Addendum No. C

To the contract documents for NORTH VERDEMONT ELEMENTARY SCHOOL, DSA No. 04-122168

For the SAN BERNARDINO CITY SCHOOL DISTRICT

LPA Project No.: 30899

HORIZONTAL  
CONTROL, PAVING,  
AND STRIPING PLAN

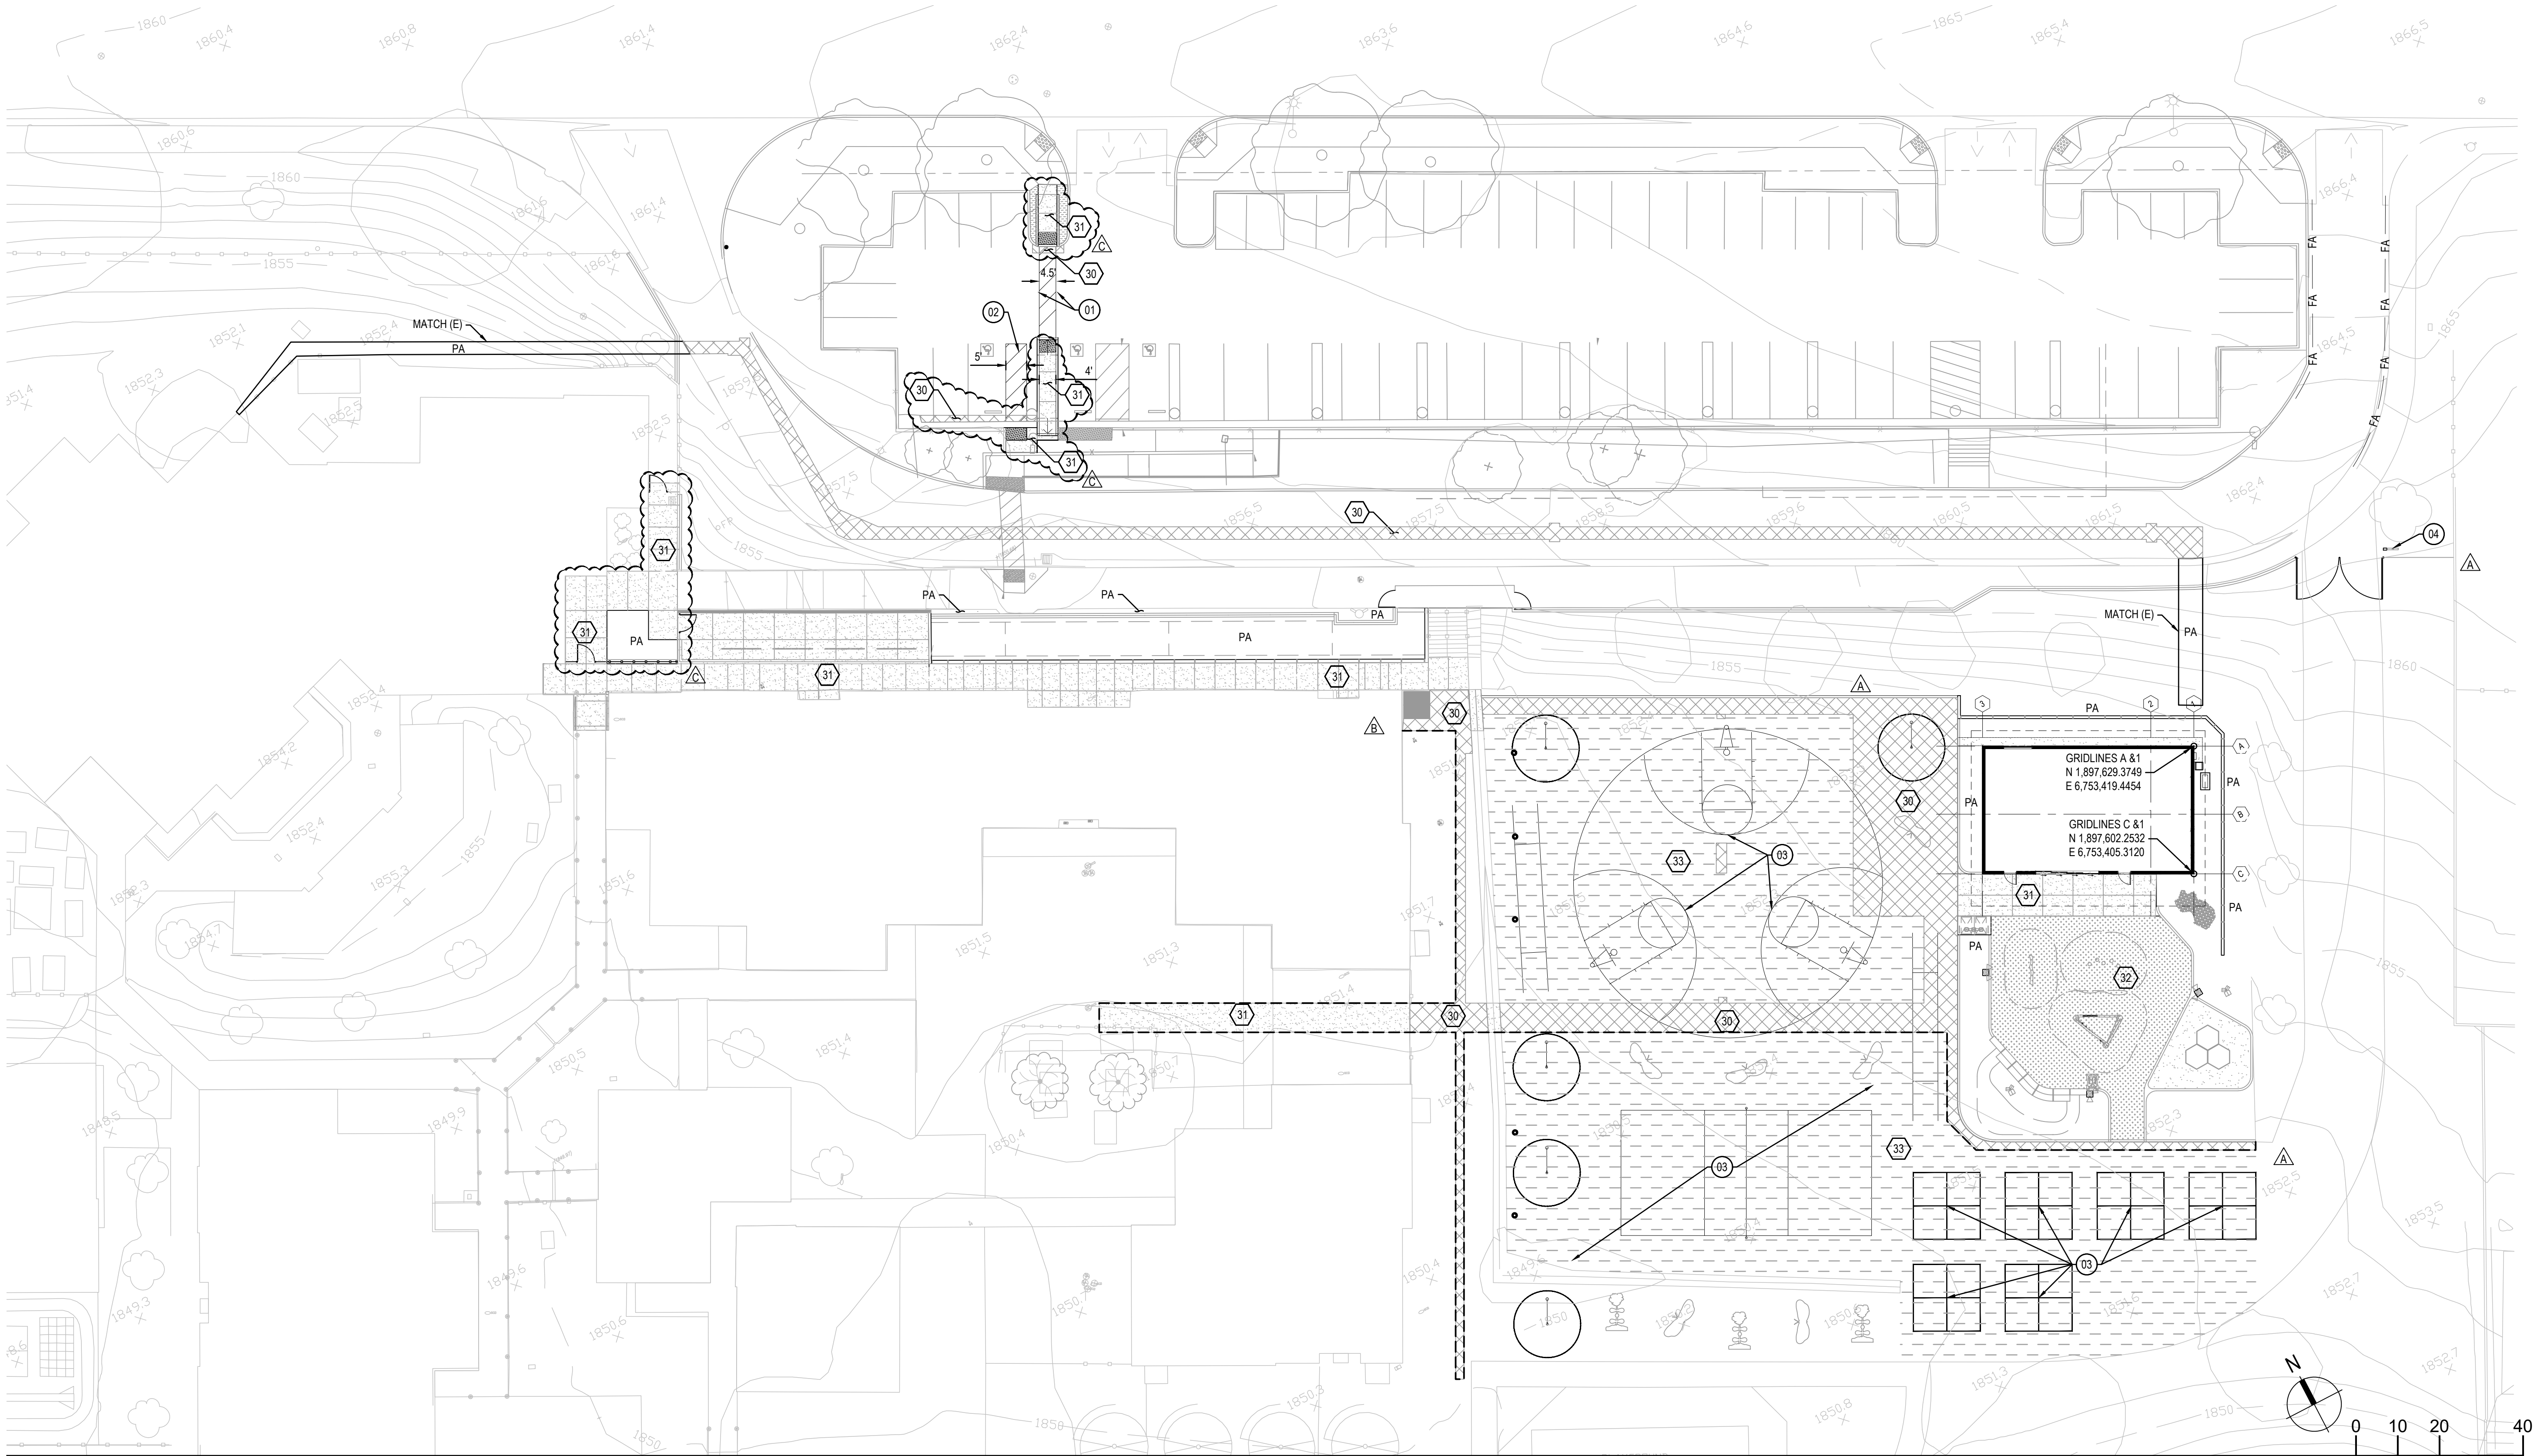
- Item No. 10**      C5.01 – HORIZONTAL CONTROL, PAVING, AND STRIPING PLAN
  - (a) Adjusted softscape and hardscape limits at new planter northwest of existing building.

- (b) Added hardscape callout at the parking lot path of travel.
  - (c) Added asphalt replacement for storm drain trenching.
- Item No. 11**      C6.01 – EROSION CONTROL PLAN

EROSION CONTROL  
PLAN

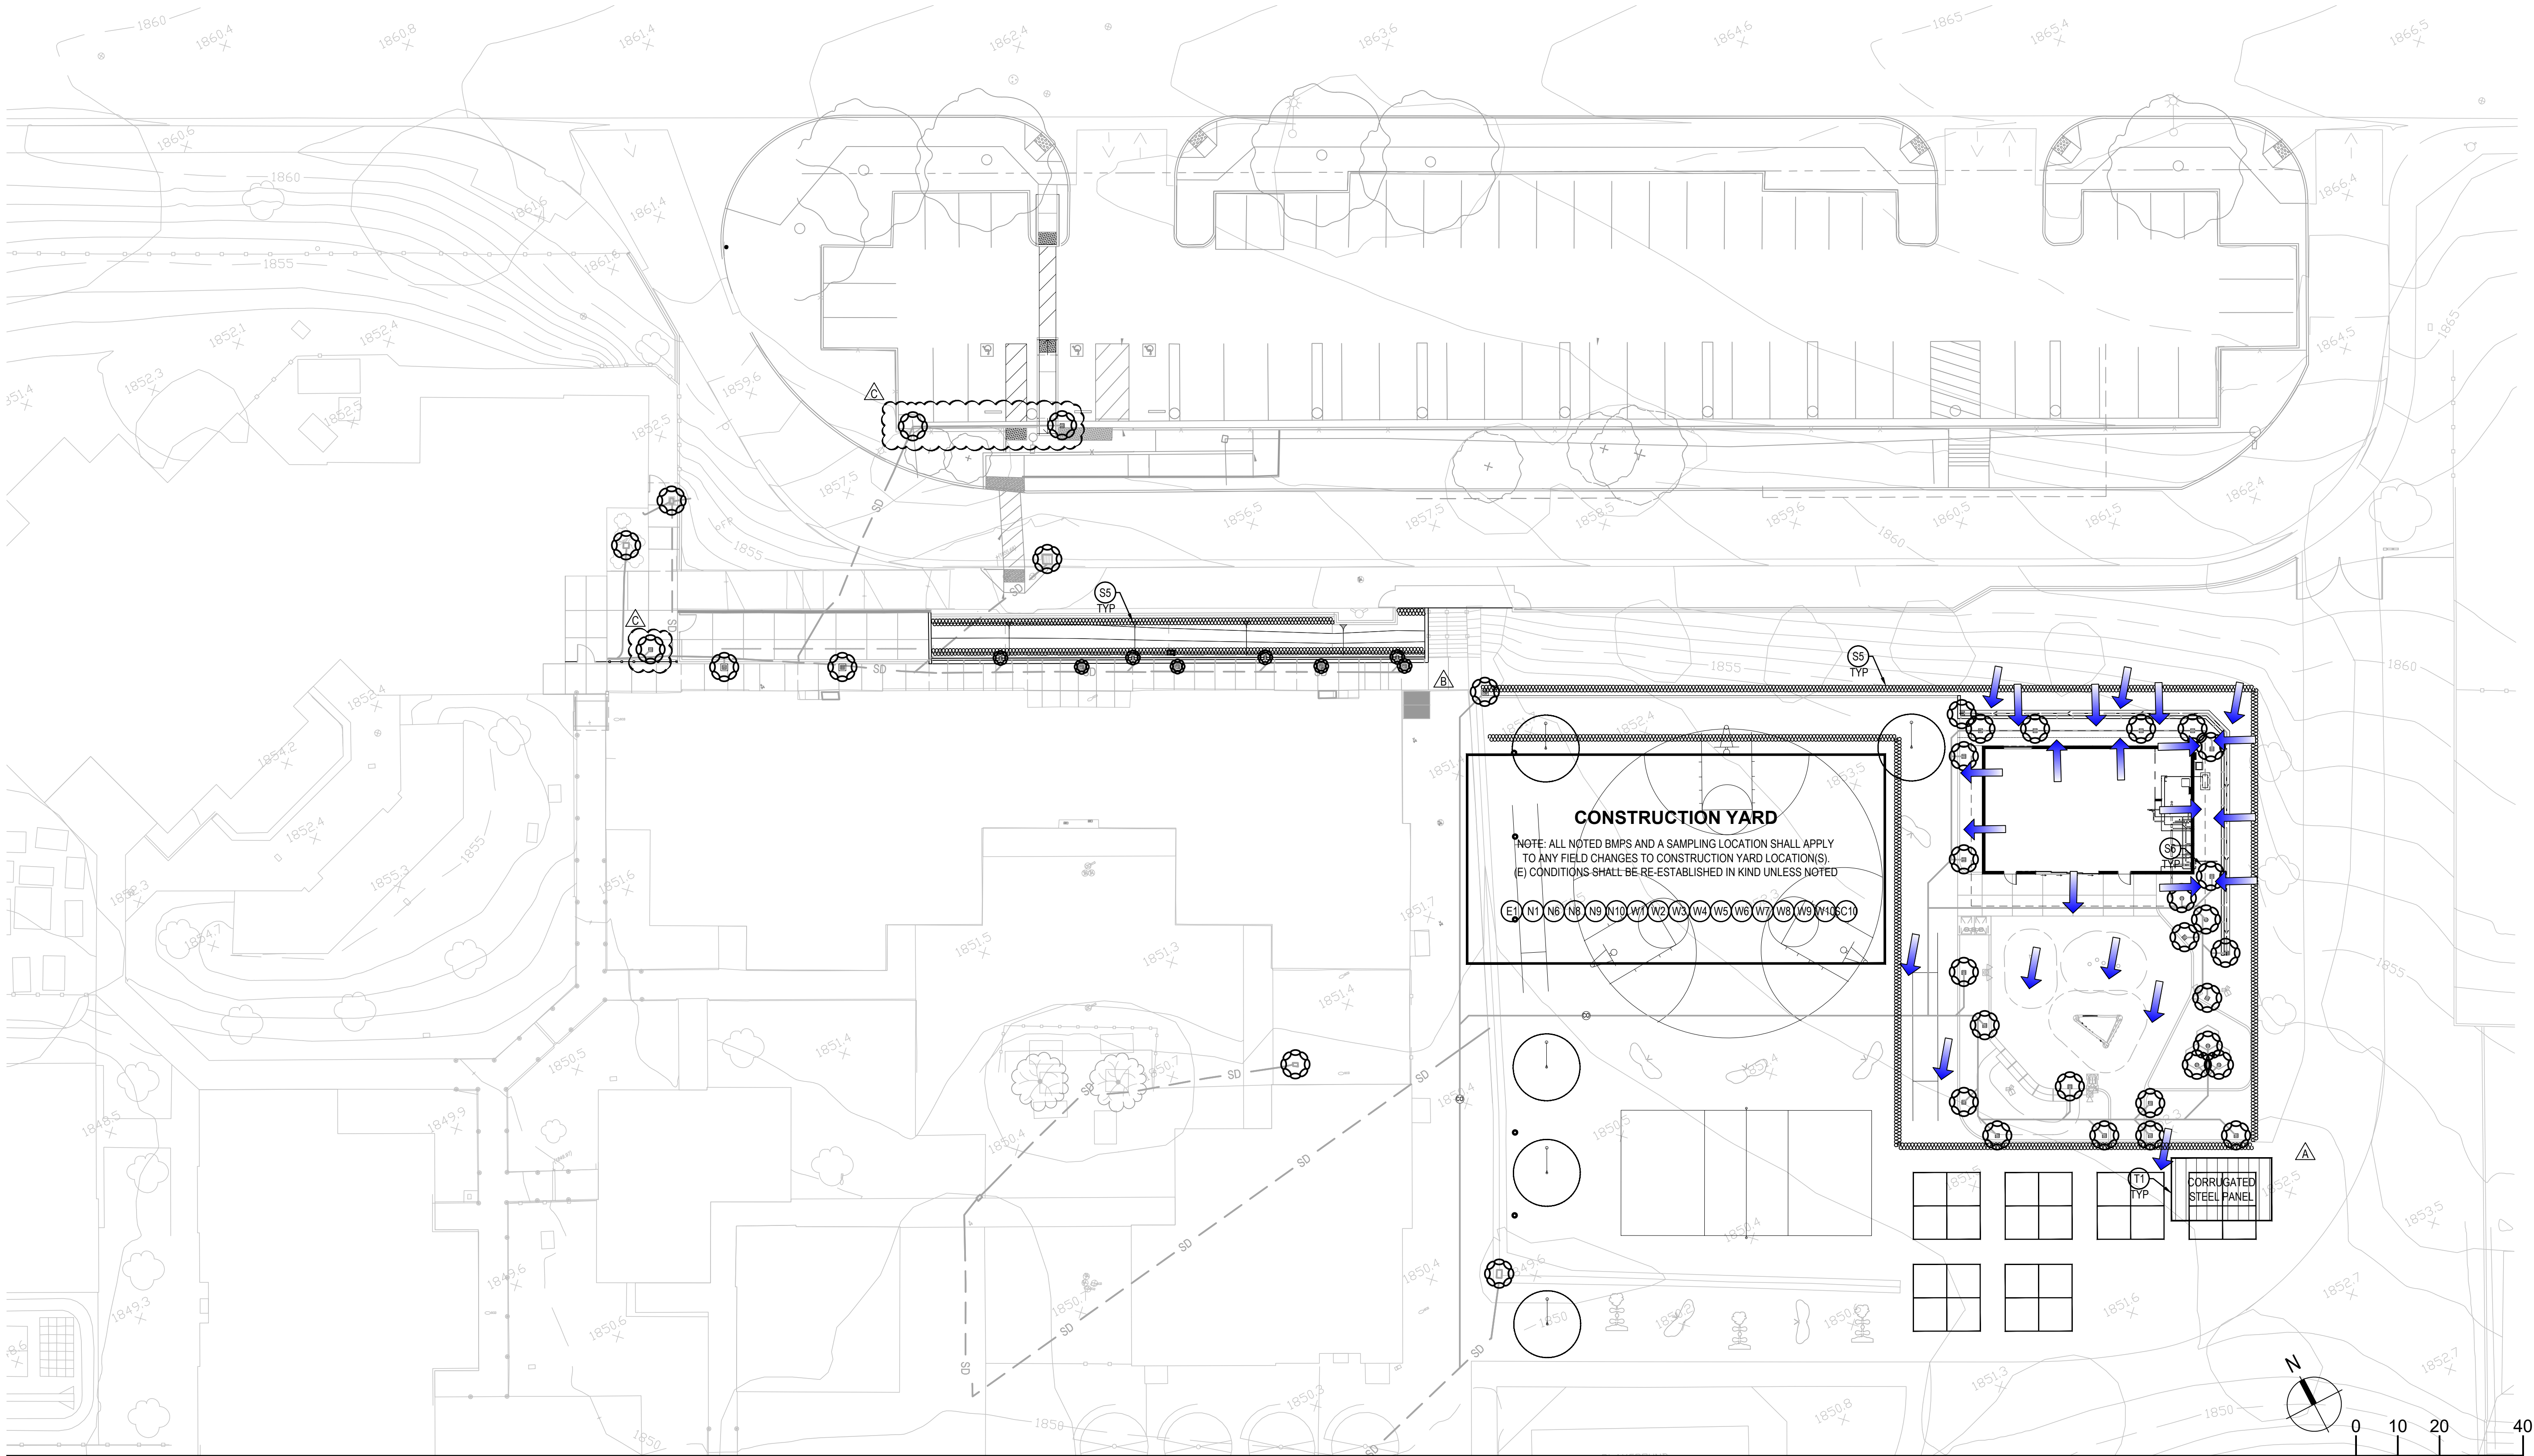
- (a) Added gravel bags at new planter northwest of existing building.
  - (b) Added gravel bags at the parking lot drain inlet.
- Item No. 12**      C7.01 – DETAILS
